SSES-FSAR

QUESTION 211.1

SUSQUEHANNA STEAM ELECTRIC STATION
UNITS 1 AND 2
FINAL SAFETY ANALYSIS REPORT

FSAR FIGURE 211.4-1

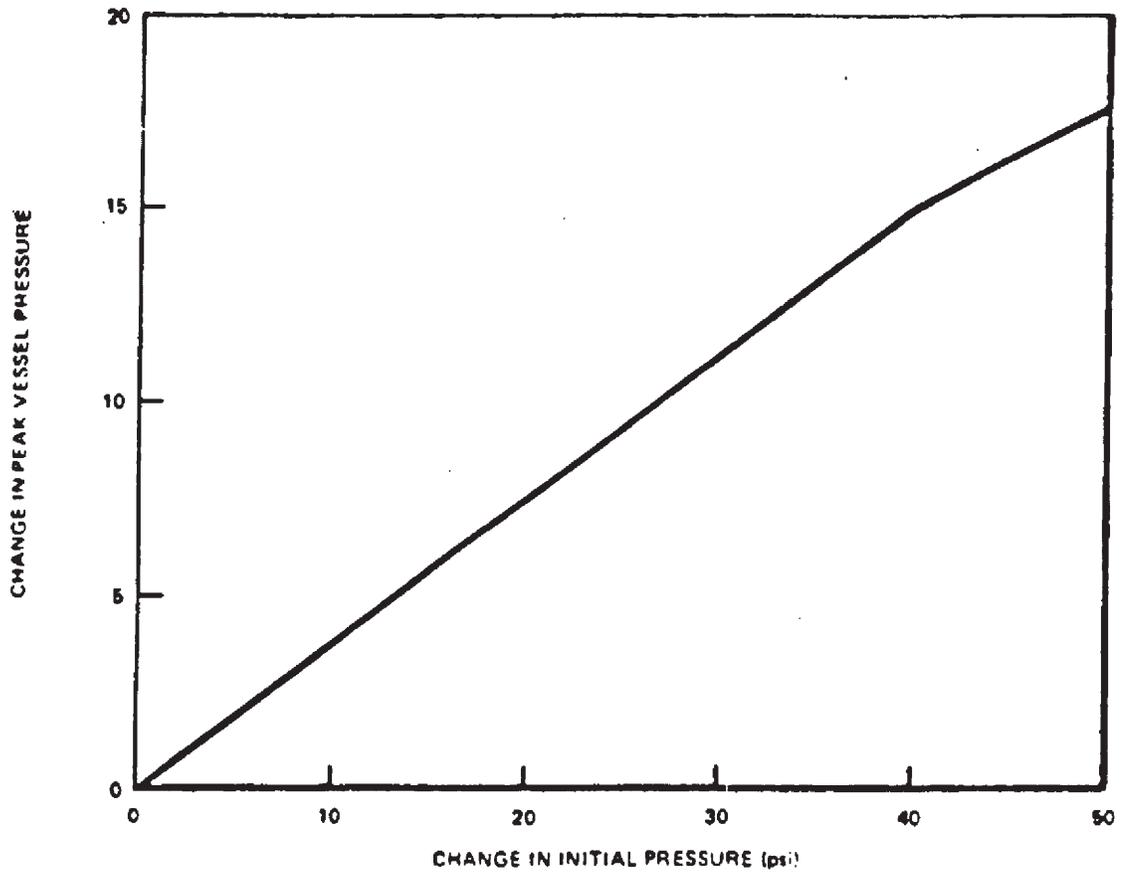
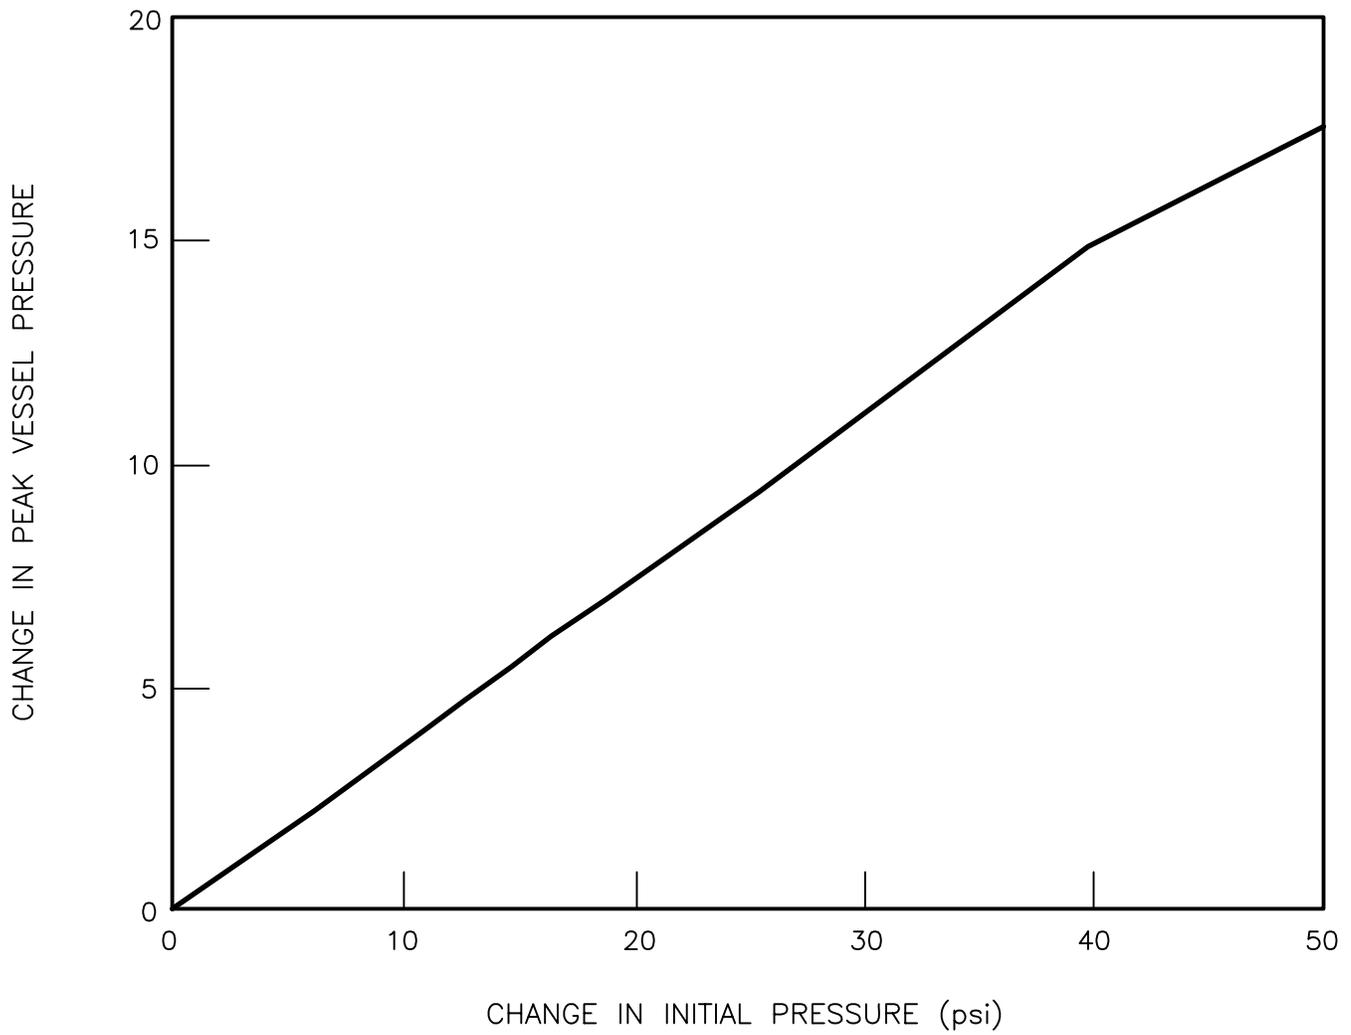
Acceptance Criterion II.2.b of SRP 5.2.2 states that, "All system and core parameters are at the values within the normal operating range, including uncertainties and technical specification limits, which would result in the highest transient pressure." Insufficient information is presented in the FSAR to determine that this acceptance criterion will be met. The applicant should confirm that the overpressure analysis will be based on an initial operating pressure (up to the Technical Specification limit) which will result in the most limiting peak pressure. The applicant should also confirm that the overpressure analysis will include the effects of the ATWS reactor recirculation pump trip on higher reactor pressure.

Acceptance Criterion II.2.c of SRP 5.2.2 states that, "The reactor scram is initiated either by the high pressure signal or by the second signal from the reactor protection system, whichever is later." The applicant has stated that the safety valve sizing analyses can take credit for the first indirect scram, which is the high neutron flux scram. The neutron flux scram occurs before the high pressure scram and results in a lower calculated peak pressure. The applicant should confirm that the safety valve sizing analyses will be based on the SRP acceptance criterion for reactor scram initiation.

The overpressure analysis shown in Chapter 5 of the FSAR assumed the plant is initially operating at 105% steam flow condition with a maximum vessel dome pressure of 1020 psig. The expected maximum operating pressure at 100% power is expected to be 1005 psig, therefore the assumed initial operating pressure of 1020 psig is expected to be conservative relative to expected actual operation. In addition, the nominal high pressure scram set point is expected to be set at 1040 psig. An analysis has been performed for a BWR-3 to investigate the effects of increasing the initial reactor pressure relative to the initial value used in the overpressure protection analysis on the peak system pressure. The conclusion was that increasing the initial operating pressure results in an increase of the peak system pressure, which is less than half the initial pressure increase as shown in Fig. 211.4-1 for the overpressure design transient (i.e., all MSIV closure with indirect high neutron flux scram). The same general trend is expected to exist for Susquehanna. For the Susquehanna project, the proposed technical specification limit on the high reactor pressure scram is 1050 psig. Therefore, the maximum increase in the initial pressure would be limited to only 30 psi and the maximum peak system pressure increase

The response to this question part (1) has been provided earlier as part of the response to Question 211.4; specifically, Paragraph 1 of the response and Figure 211.4-1.

FSAR FIGURE 211.70-2

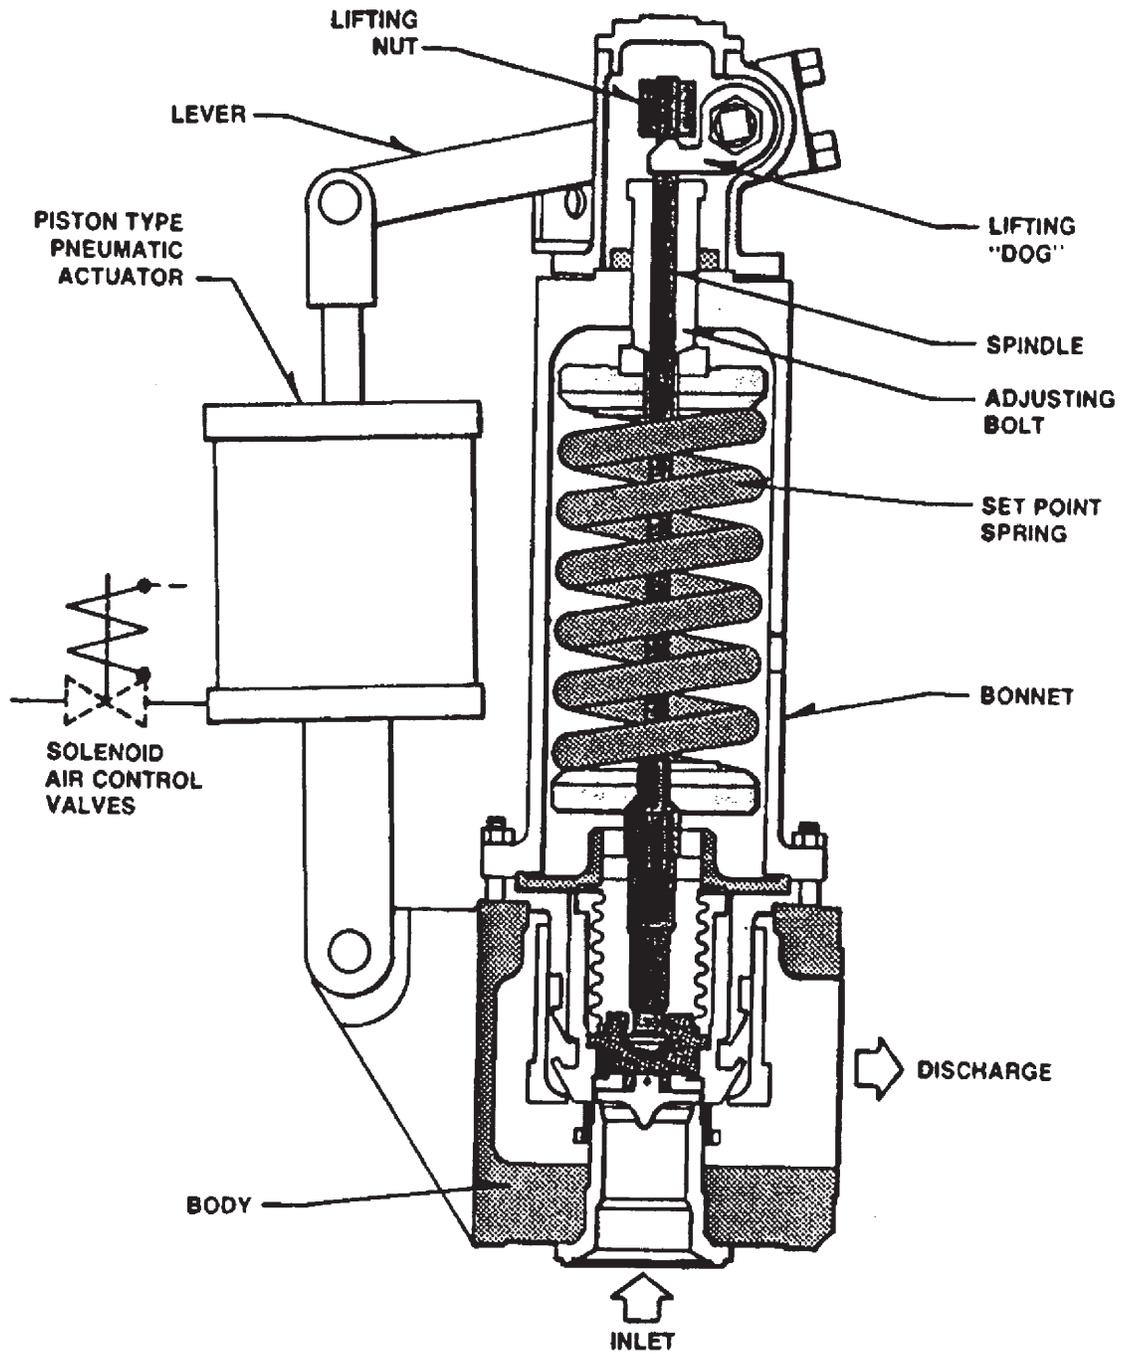
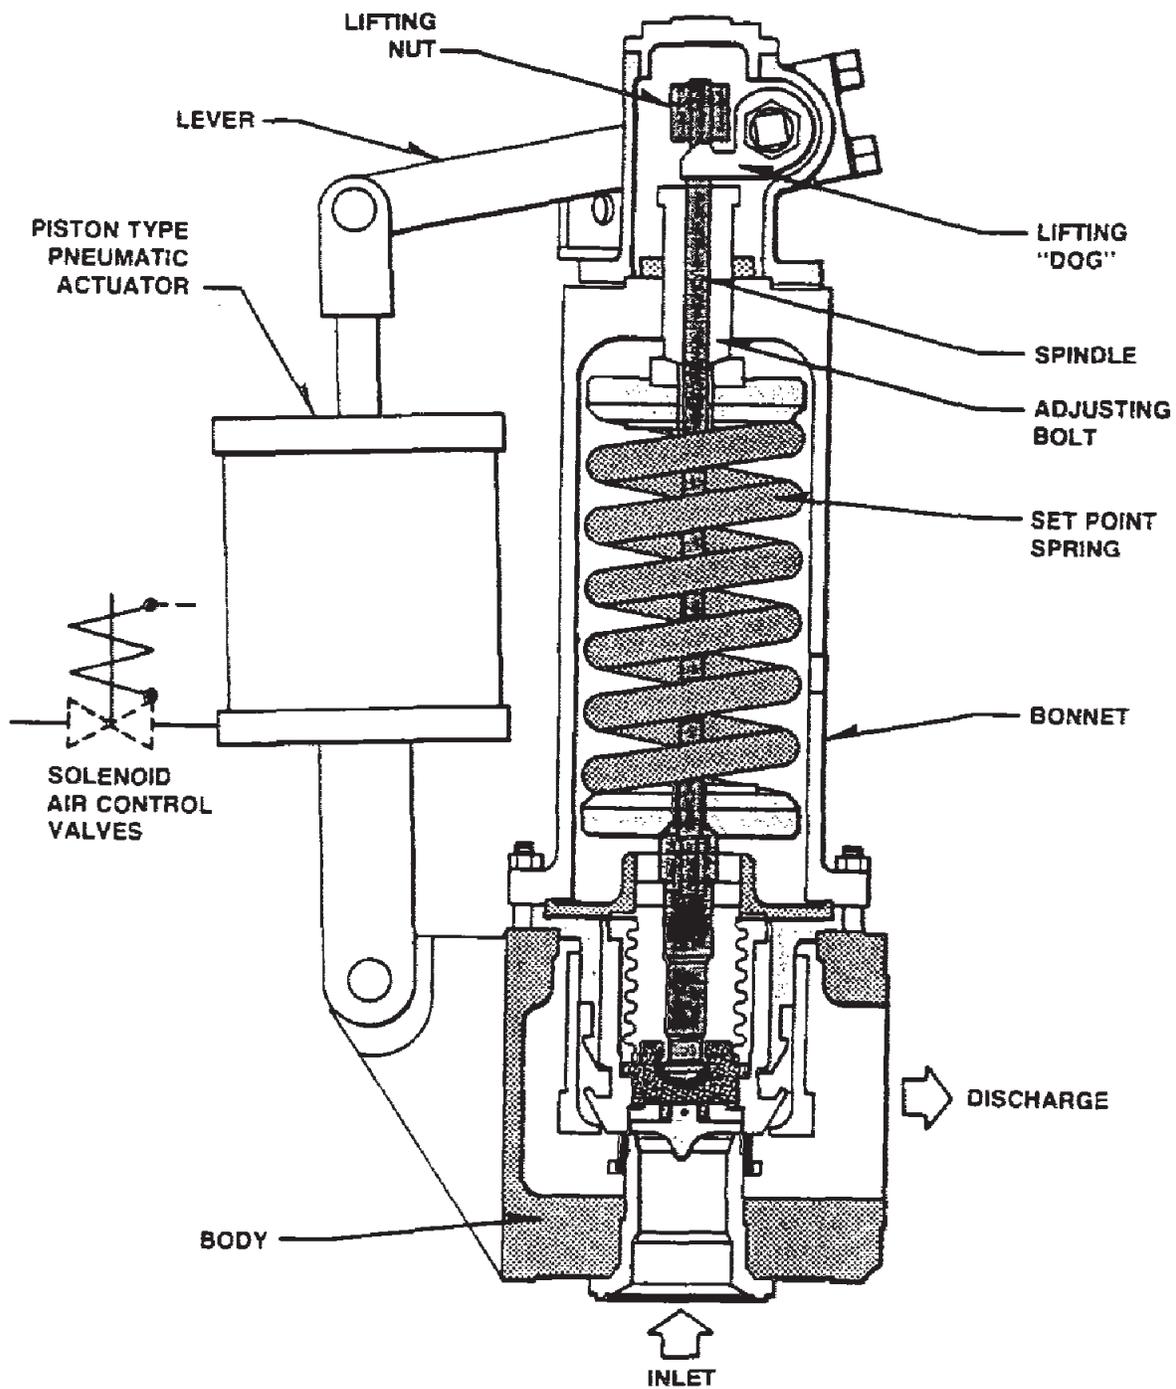
In 7.3.1.12.1.4.2, you state that a dual solenoid-operated pilot valve controls the pneumatic pressure applied to the "bellows actuator" which controls the safety/relief valve directly. In Figure 211.70-2, you show a cross-section of a Crosby valve which has a piston type pneumatic actuator. Also, in Table 211.70-1, you state that the SSES safety/relief valves have no pilot valves but in Section 7.3.1.1a.1.4.2, you state that the air accumulator is sized to provide air for five actuations of the pilot valve following a failure of the pneumatic supply. Resolve these discrepancies.

FIGURE 211.119-1, Rev 47

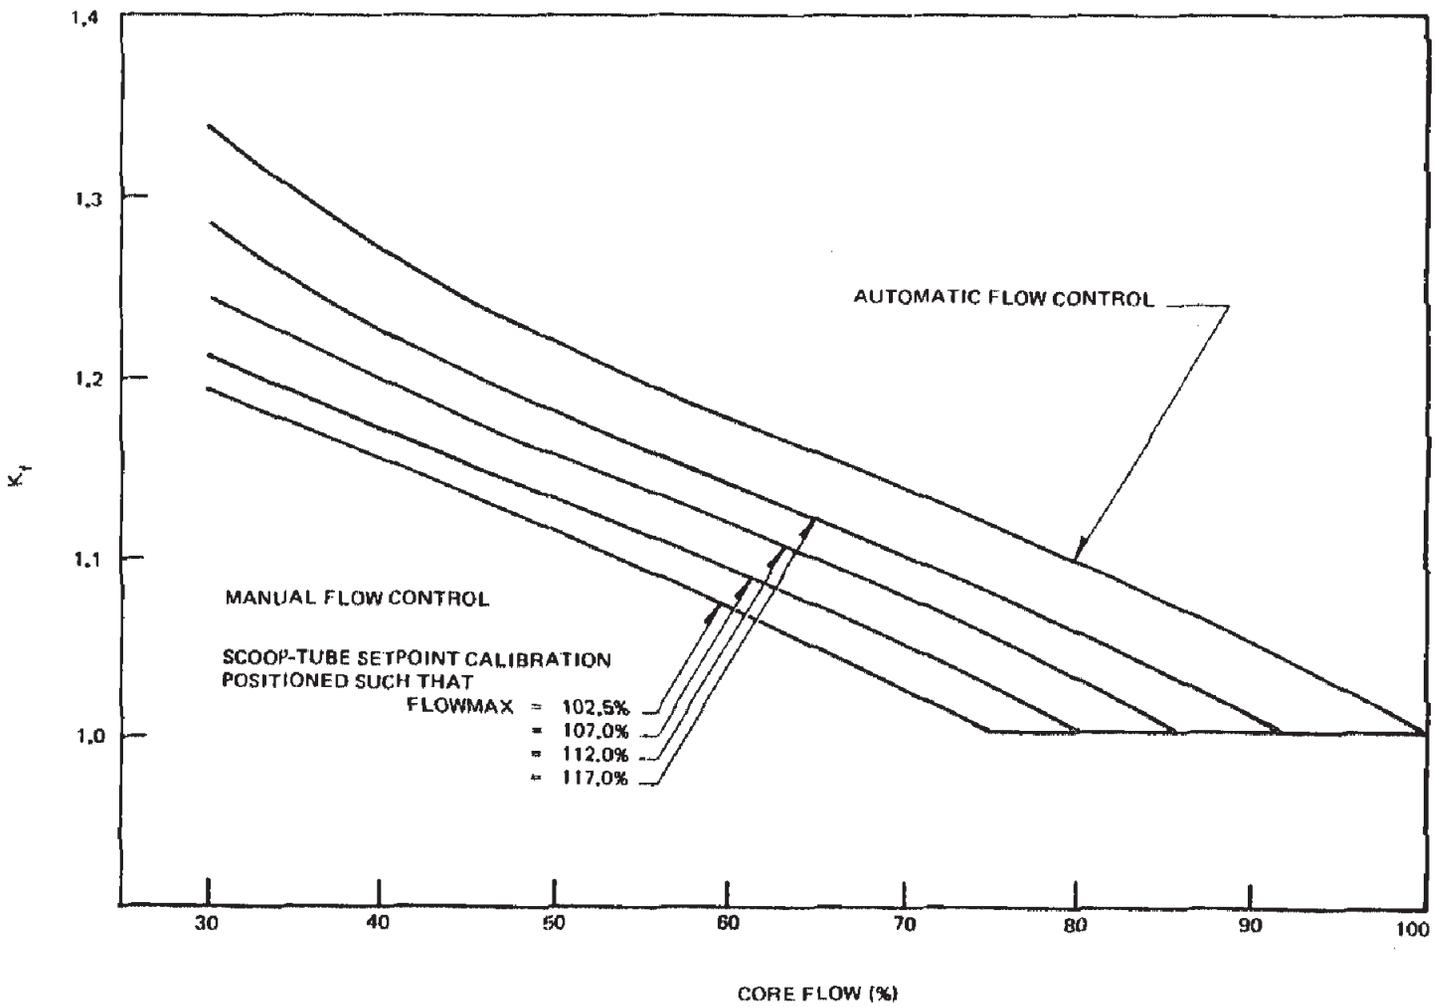
For the recirc flow control failure with increasing flow transient (Section 15.4.5) provide the initial operating MCPR determined at 65% NB rated power and 50% core flow. In addition, provide the K_f factors as a function of core flow for the automatic and manual flow control modes of operation. Furthermore, provide the maximum flow control set point calibration limit (e.g., 100% or 105% of rated flow) for the recirc loop flow control valves used in the transient analysis.

Provide recirculation pump M-G set points for the manual flow control mode assumed in the analysis. Also, you reference the GE topical report NEDO-10802 as the dynamic model to simulate this event. Since NEDO-10802 does not describe the complete event, discuss in greater detail the overall method used to calculate the CPR.

The initial operating MCPR at 65% nuclear boiler rated power (initial core, before power uprate) and 50% core flow was 1.23, assuming slow runout to 102.5% of rated flow.

A plot of K_f factors versus core flow is shown on Figure 211.119-1. Note that the M-G set points for the manual flow control mode are shown on the figure; because flow control is provided by M-G sets there are no flow control valves and thus no flow control set points.

FSAR FIGURE 211.178-1

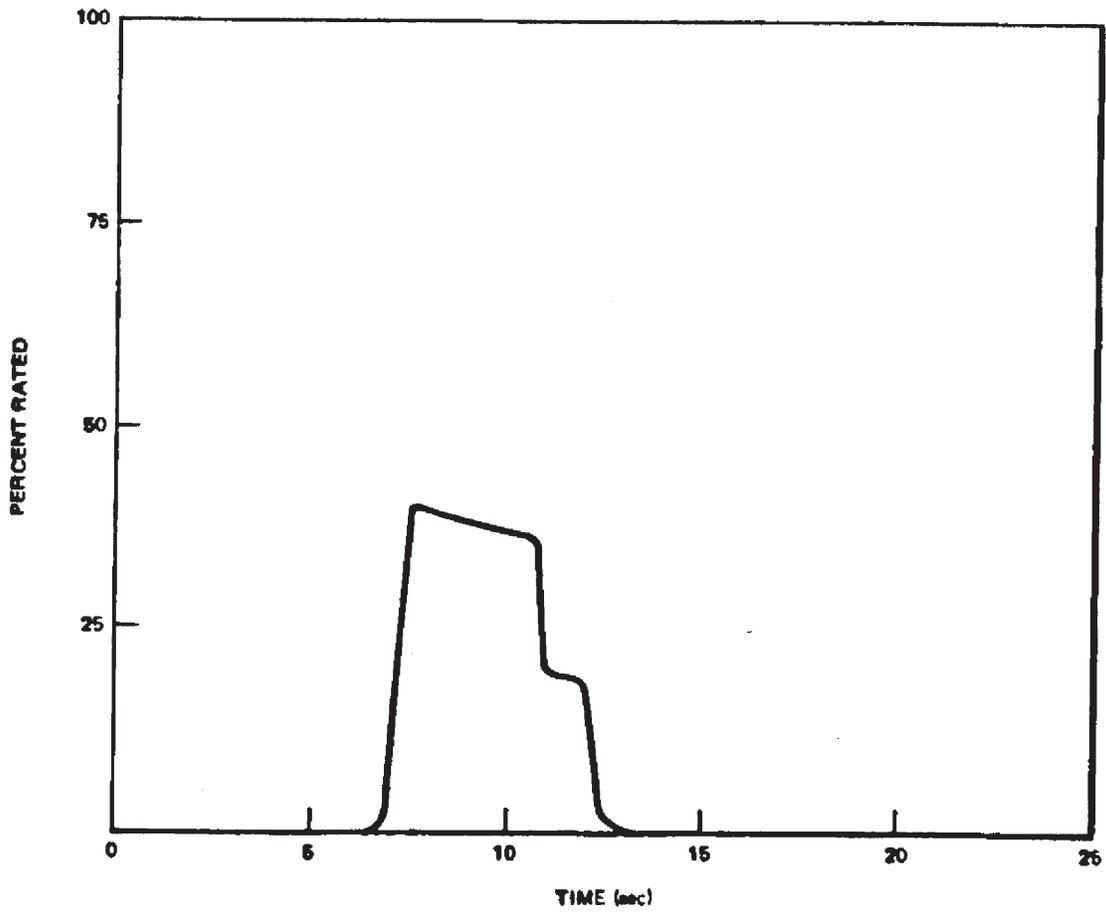
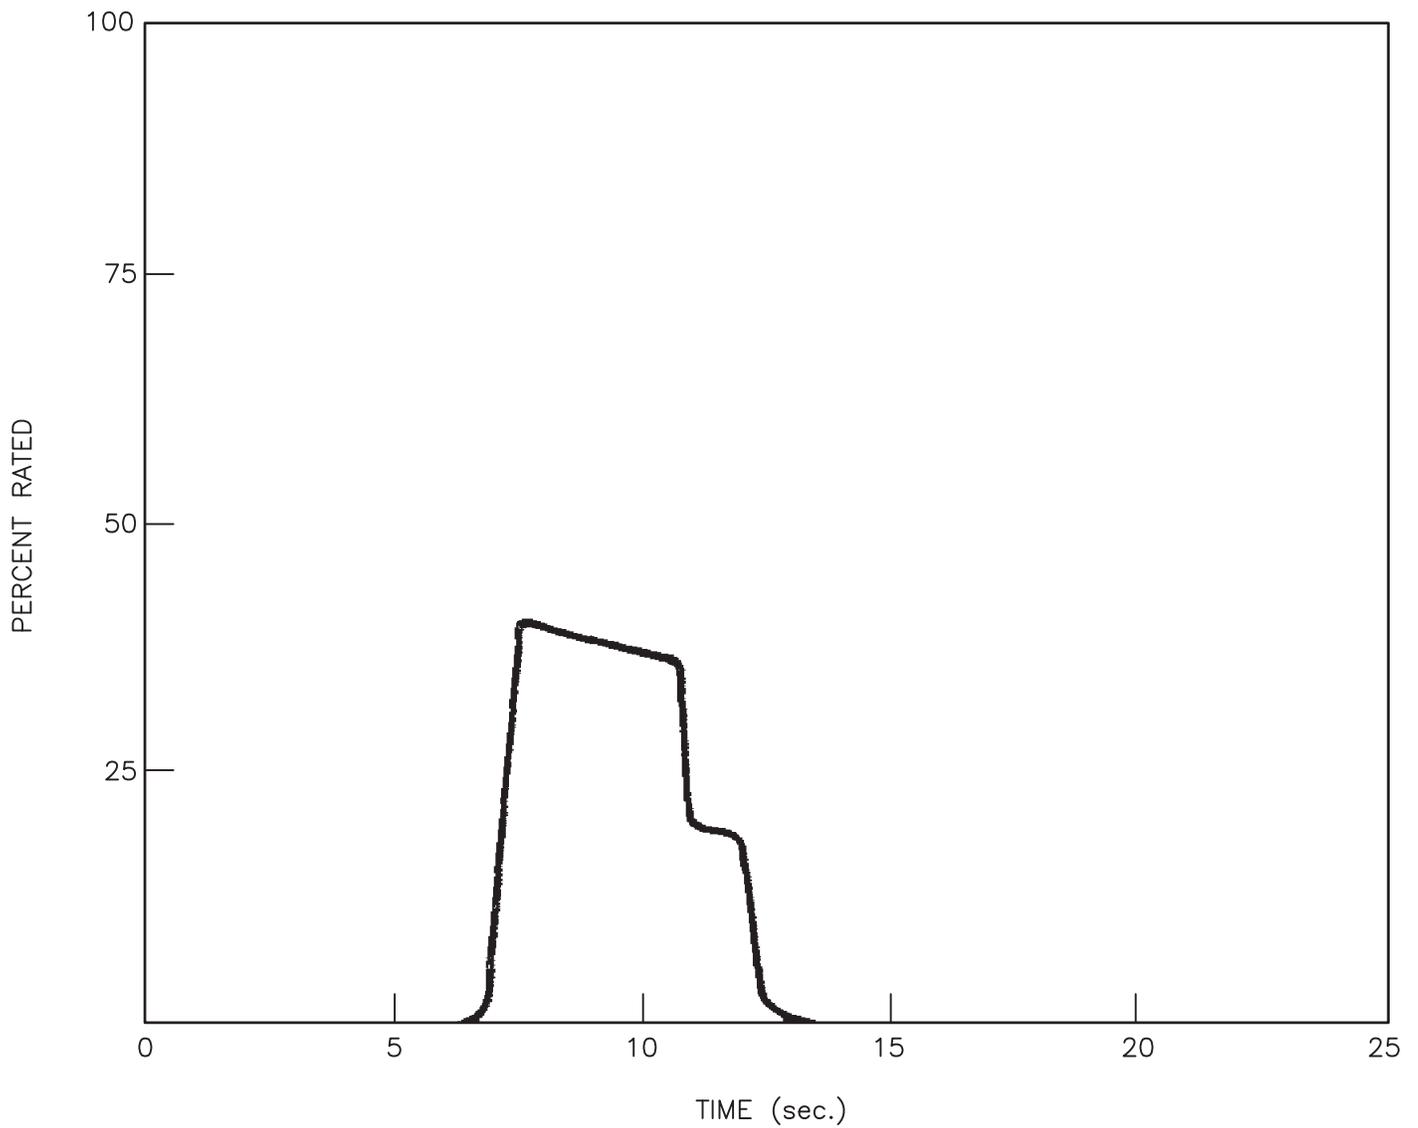
Include relief valve flow in Figure 15.3-2.

Relief valve flow is included in Figure 15.3-2. The upper left quadrant indicates total steam flow, upper right quadrant indicates bypass flow. Since the turbine has been tripped the difference between these flows is the safety relief valve flow. Relief valve flow is shown in Figure 211.178-1.
